PLAN AND ZONING COMMISSION MEETING

CITY OF DAVENPORT, IOWA

TUESDAY, OCTOBER 15, 2019; 5:00 PM

Case F19-17: Request of Townsend Engineering for Final Plat for a 2 lot subdivision on 3.28 acres, more or less, of property located at 4729 Progress Drive containing. [Ward 6]

PRELIMINARY PLAT OF PADDINGTON SQUARE AN ADDITION TO THE CITY OF DAVENPORT, IOWA

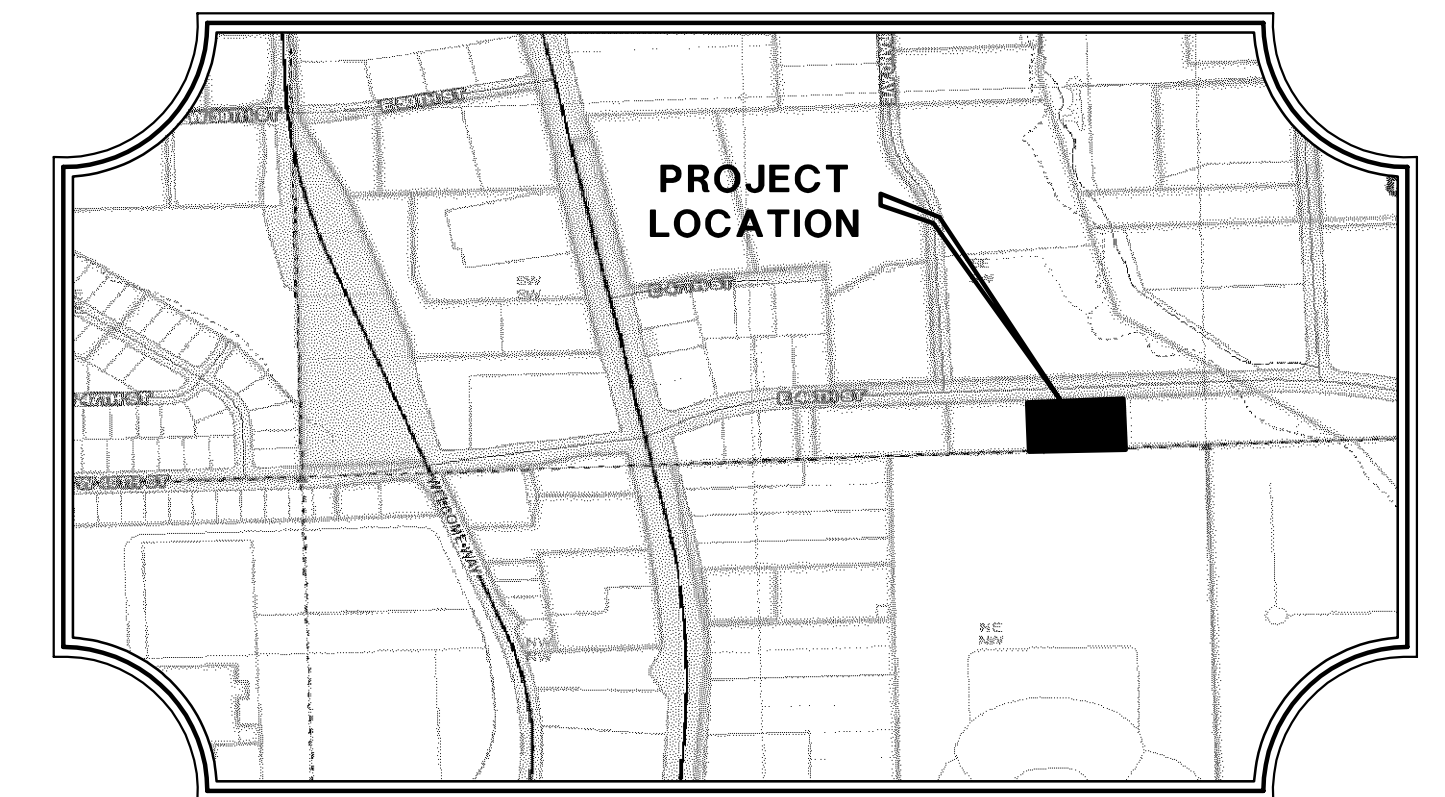
Storm Water. The development will include more than 5,000 square feet of hard surface. With R-MF zoning, the maximum impervious surface coverage will be 70% of each of the 7 buildable lots. Otherwise, the development will need to comply with the City's stormwater requirements.

Sanitary Sewer. The property is served by an 8" main on the south edge of 46th St.

1. That a drainage easement sized to convey 100 year storm from the individual lots to the outlot.
2. That a shared access easement with the adjacent property owner be provided for the existing drive entrance for use and potential maintenance.
